# UN Regulation No. 90 – CoP

## Annex 9 – 3.1.1 (HCV)

Document replacing GRVA-09-41 and GRVA-07-52

# The new proposal – Annex 9 / 3.1.1. - HCV

# Typical EOS temperatures on R90 HCV Approval Tests

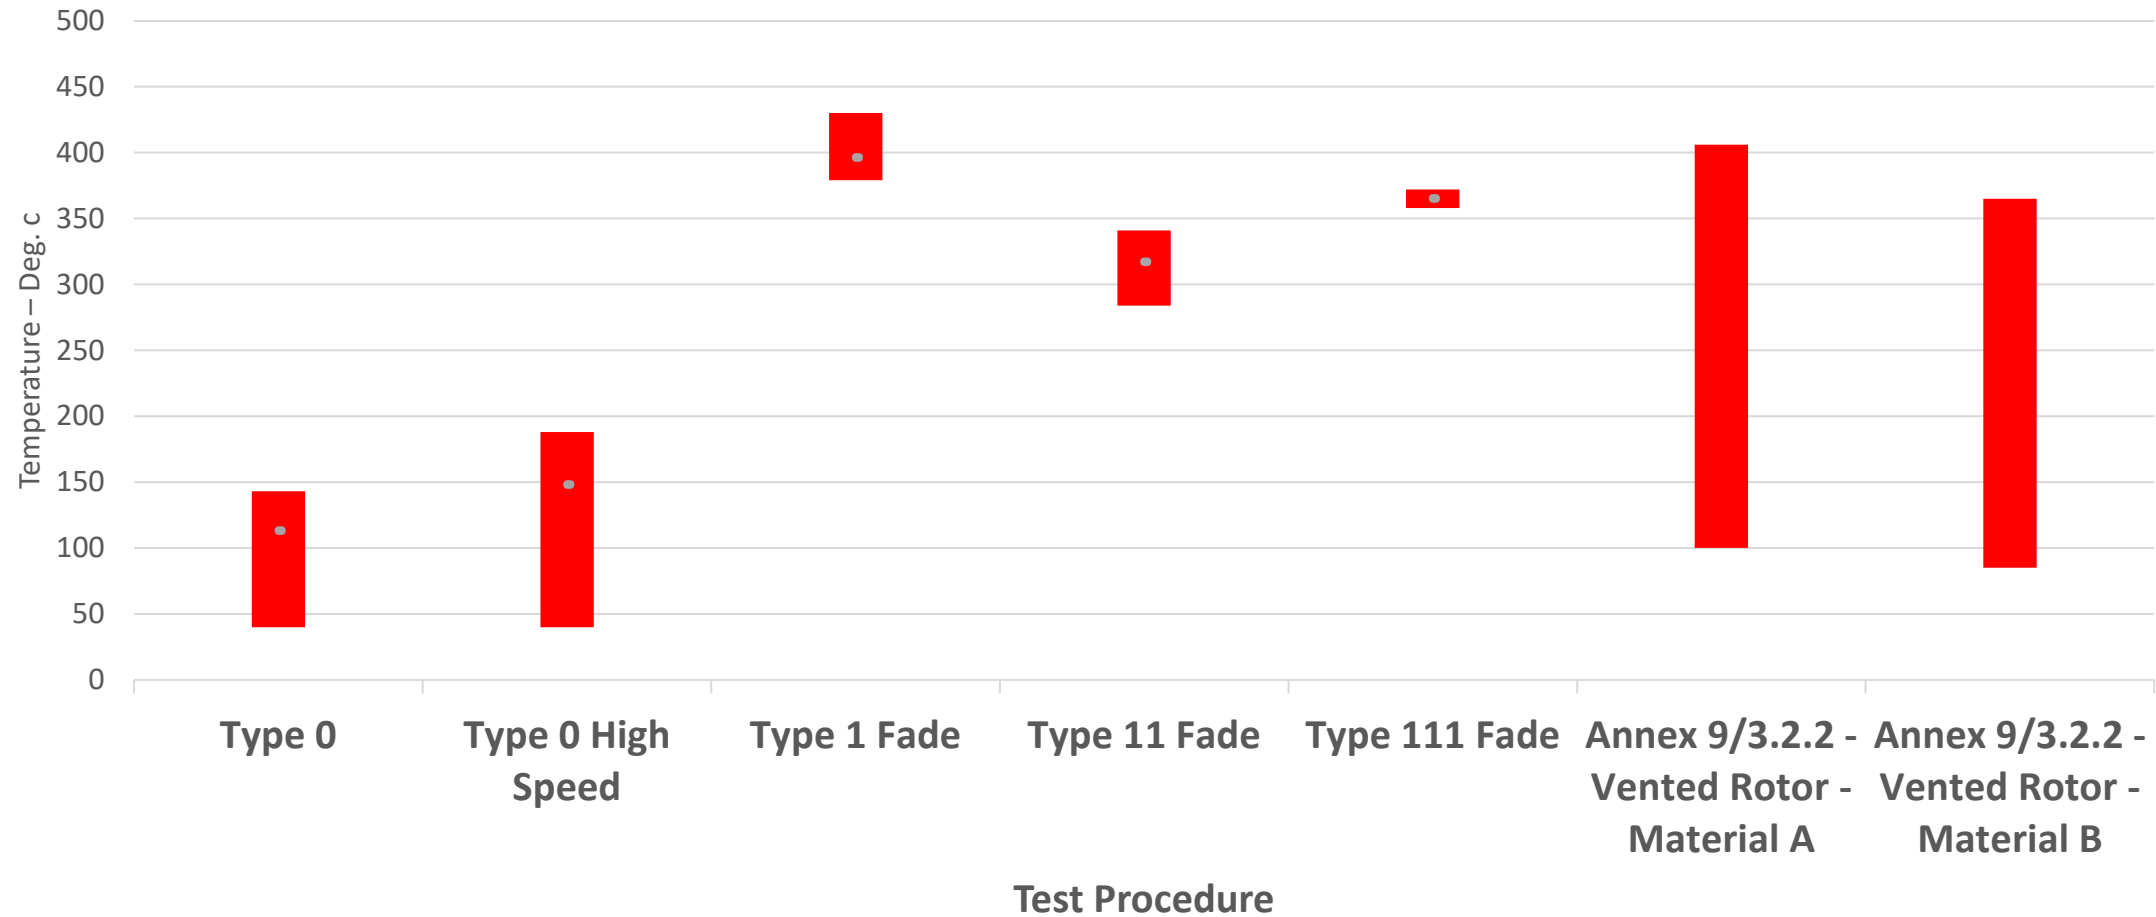
- 1) Use of alternative type of brake calliper – *Agreed*
- 2) Use of alternative type of brake disc
  - Vented rotor will result in lower EOS temperatures – will these be lower than temperature range experienced on approval tests ?

- Annex 9 /3.2.2. specifies start temperatures - no requirement for EOS
- Annex 9 /3.2.2. is an industry CoP test with surrogate parts, not an approval test – no requirement for temperature matching
- EOS temperature is a product/test variable not a control parameter

Annex 9 / 3.2.2. tests with vented rotors broadly cover the temperature spectrum seen on R90 Approval tests
